**CITY OF MERIDIAN
FINDINGS OF FACT, CONCLUSIONS OF LAW
AND DECISION & ORDER**

In the Matter of the Request for annexation and preliminary plat for Shafer View Ridge Subdivision, by Gregg Davis, Breckon Land Design.

Case No(s). H-2025-0047

COMMUNITY DEVELOPMENT DEPARTMENT REPORT

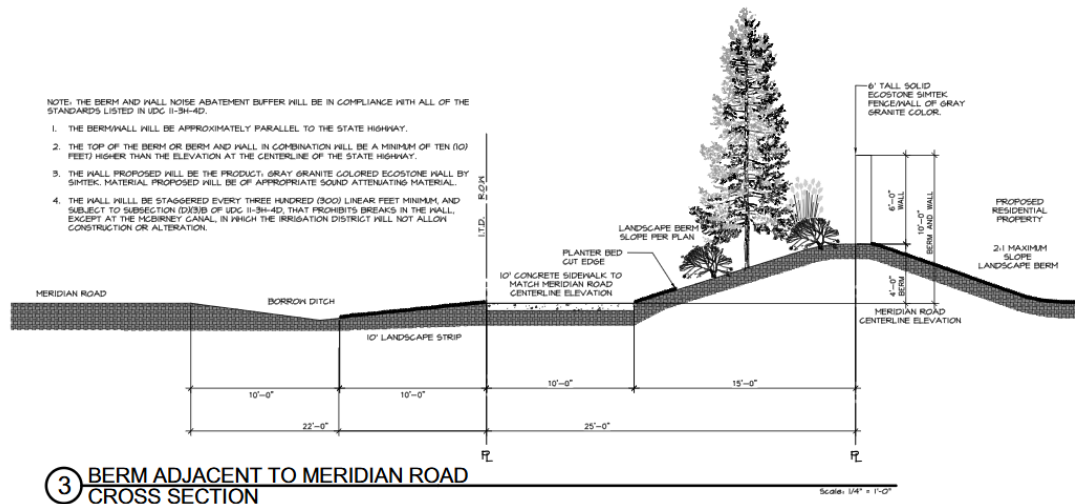
As the property is within close proximity to SH-69, the applicant will be required to provide noise abatement per UDC 11-3H-4D. Noise abatement could include but not limited to a berm or a berm and wall combination to help reduce the traffic noise.

The applicant states this requirement can be met using the existing cut bank along Meridian Road, which will act as a berm, in combination with a wall extending 10 feet above the highway centerline. The fence will be designed to incorporate architectural elements and to break up monotonous wall planes as required. See berm cross section below.

G. Open Space Exhibit (date: 3/10/2026)

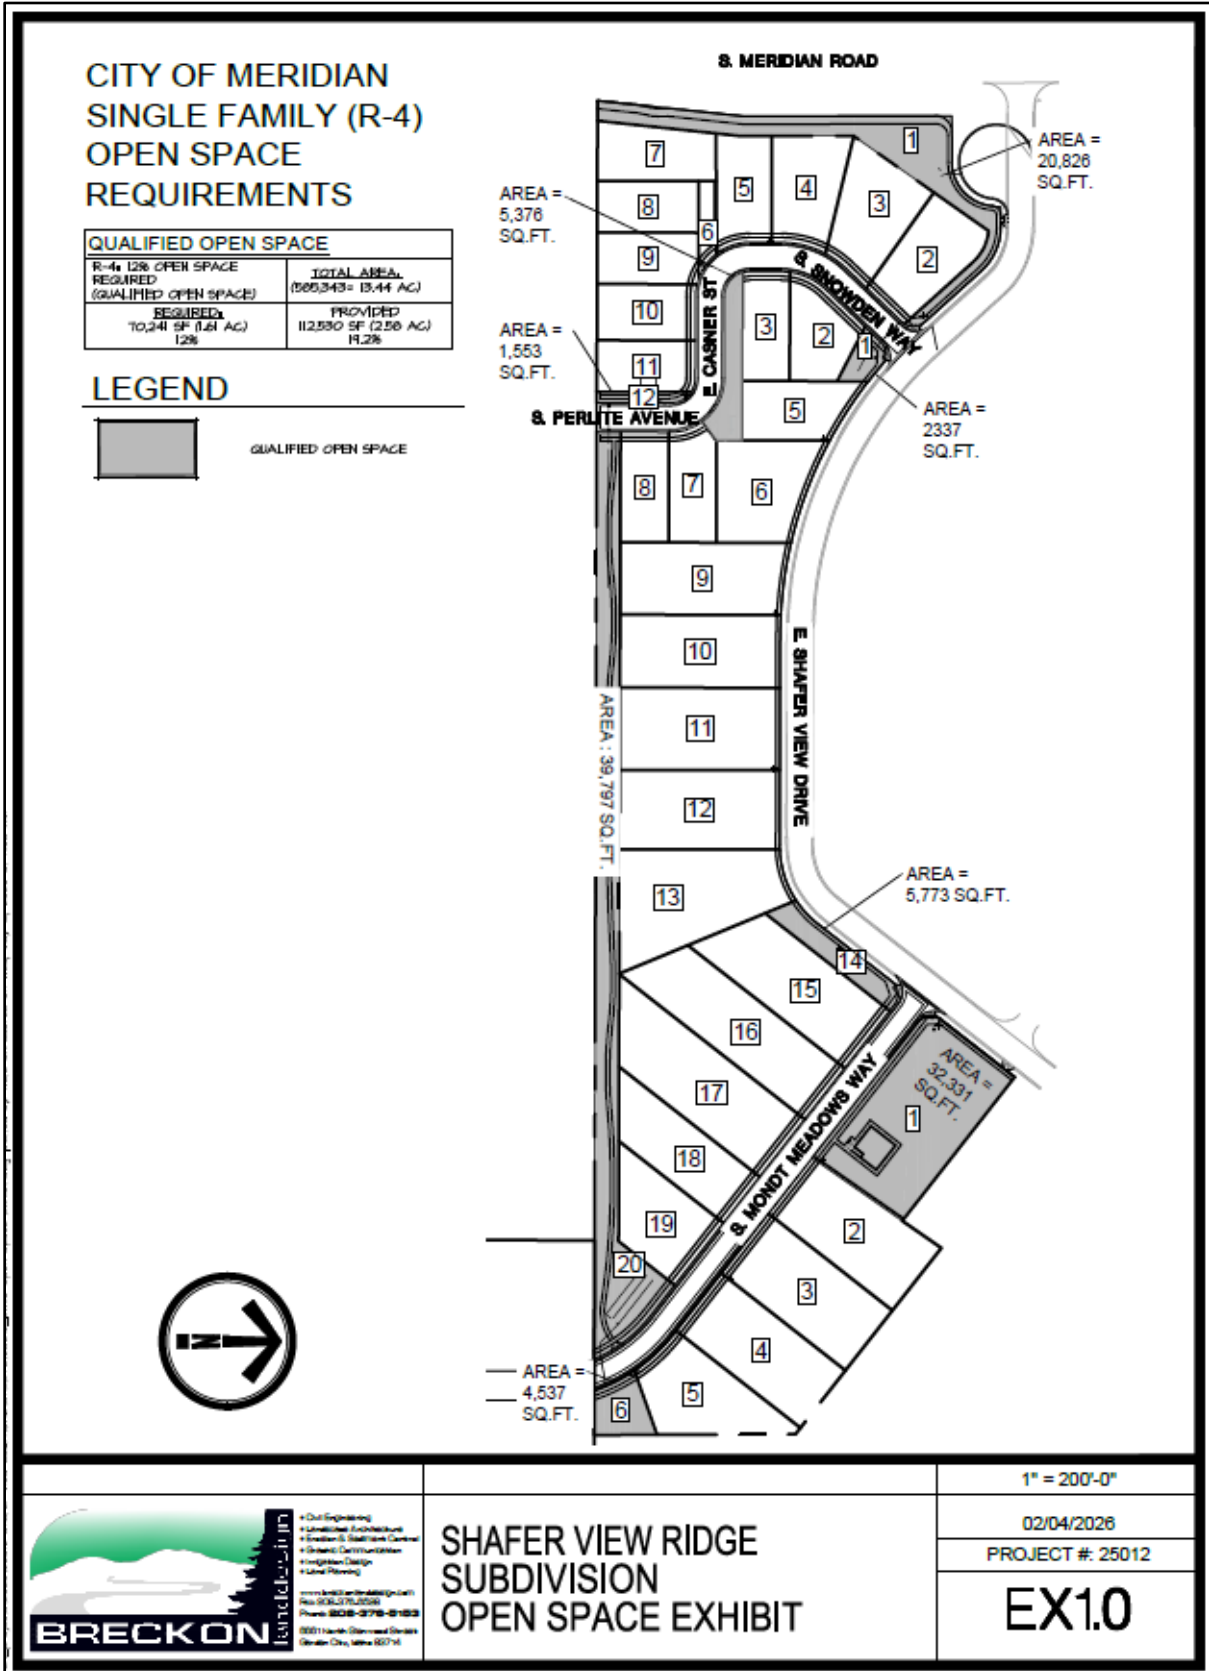
Based on the standards in UDC Table 11-3G-3, a minimum of 12% (or 01.61-acres) for the R-4 zoning district of qualified open space is required to be provided within the development. An open space exhibit was submitted as shown in Section VII.F, that depicts 22% (or 3.04-acres) of open space that exceeds the required quality and qualified open space standards.

Based on the standards in UDC 11-3G-4A, a minimum of three (3) amenity points are required as the overall project is 13.44 acres in size. The amenity proposed is a playground with a six (6) foot long bench. All common open space areas are required to be landscaped with one deciduous shade tree for every 5,000 square feet of area and include a variety of trees, shrubs, lawn or other vegetative groundcover per UDC 11-3G-5B.3.

- c. Direct lot access to S. Meridan Road is prohibited.
 - d. No building permits shall be issued prior to the plat being recorded.
 - e. The Open Space amenities shall meet the following requirements: provide a playground and bench as depicted in Exhibit VIIF.

H. Block Length Exhibit (date: 3/10/2026)

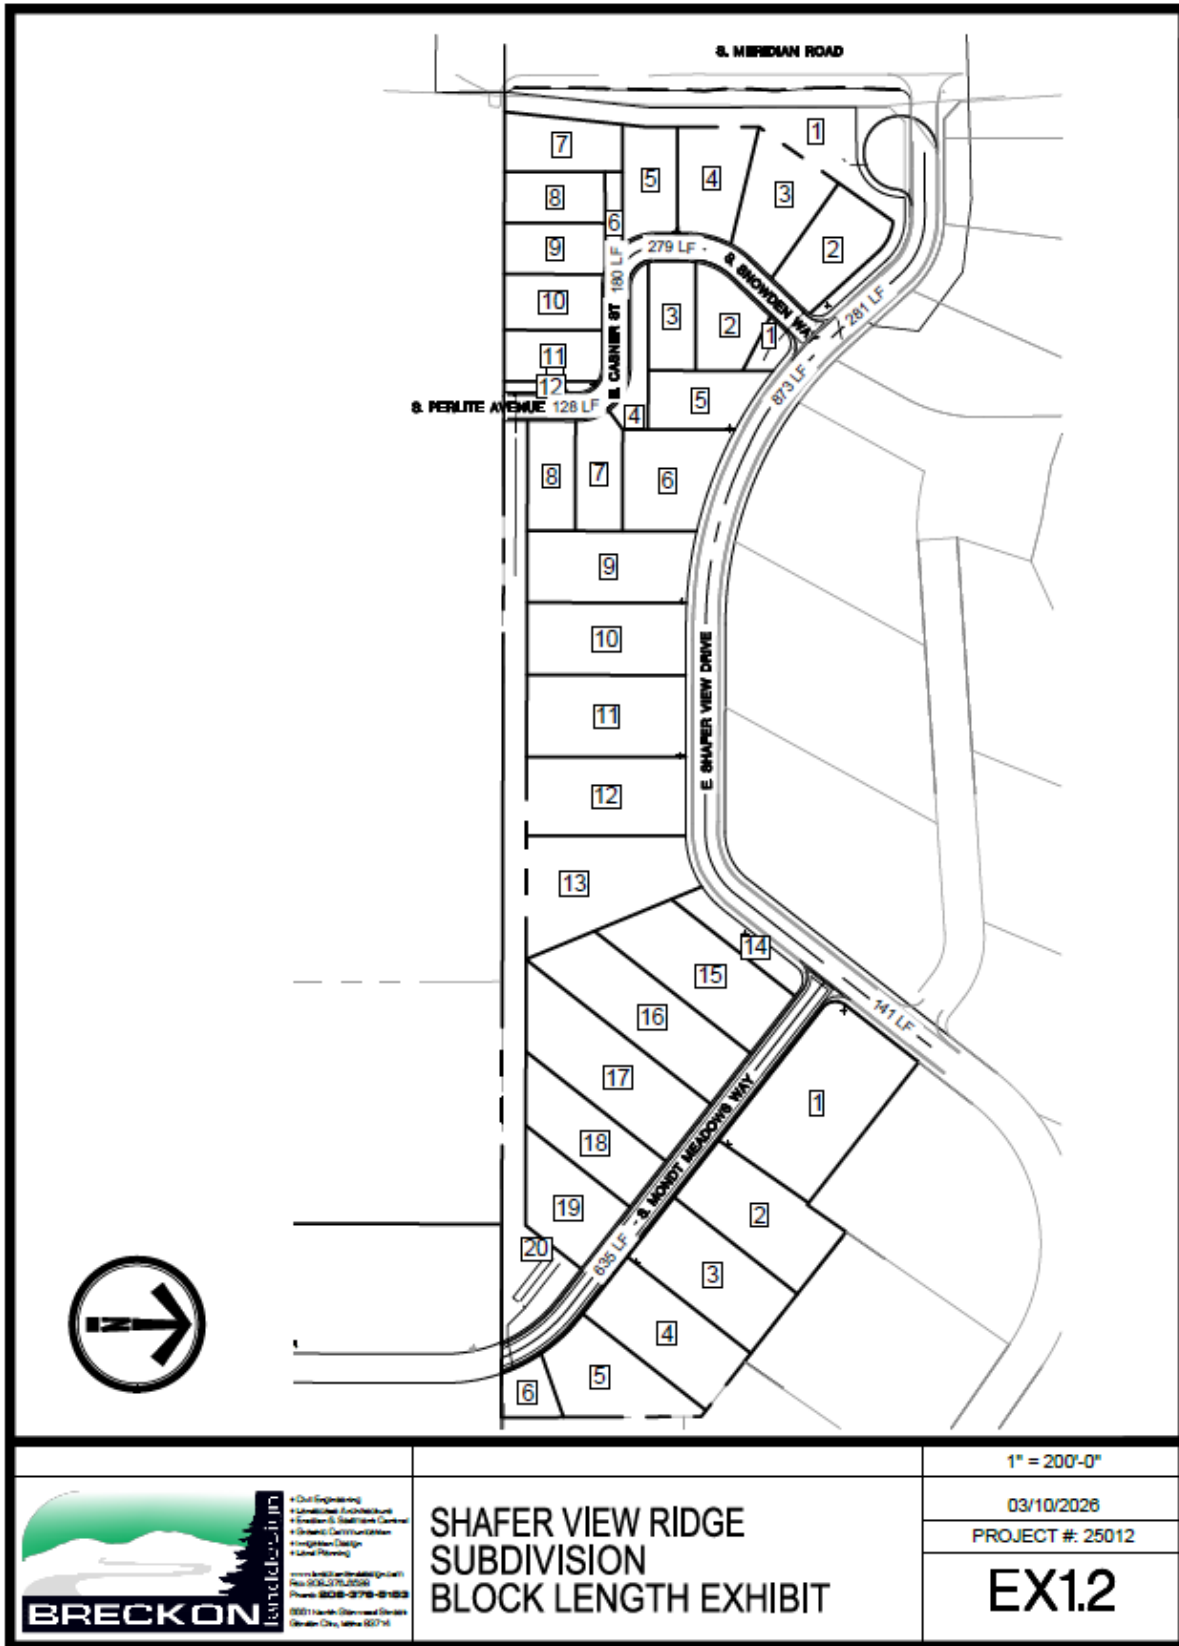
The existing street, Shafer View Drive, measures approximately 1,194 feet along the north side and approximately 873 feet along the south side, both of which exceed the maximum block length standard of 750 feet as established by the Unified Development Code (UDC). As a result, the block does not fully comply with the UDC block length requirements intended to promote walkability, pedestrian connectivity, and an interconnected street network.

Accordingly, the applicant is requesting a waiver from City Council to allow the block face to exceed the maximum block length standard. This request is based on the existing configuration and alignment of Shafer View Drive, which was constructed within Ada County prior to the current development proposal and outside the context of the City's adopted block length standards. The applicant has stated that the size and irregular shape of the subject property, combined with the proposed residential lot layout and lot sizes, limits the ability to further subdivide the block.

Pursuant to UDC 11-6C-3.F.3.a, block faces within residential zoning districts may be extended up to one thousand (1,000) feet when a pedestrian connection is provided to

maintain connectivity for non-vehicular travel. In support of this standard, the applicant has provided a detached sidewalk along the south side of E. Shafer View Drive, which establishes a continuous pedestrian connection through the subdivision and enhances access for pedestrians. While the north block face exceeds the one-thousand-foot allowance, the provision of pedestrian infrastructure helps mitigate the impacts associated with the extended block length by supporting safe and convenient pedestrian movement consistent with the intent of the UDC.
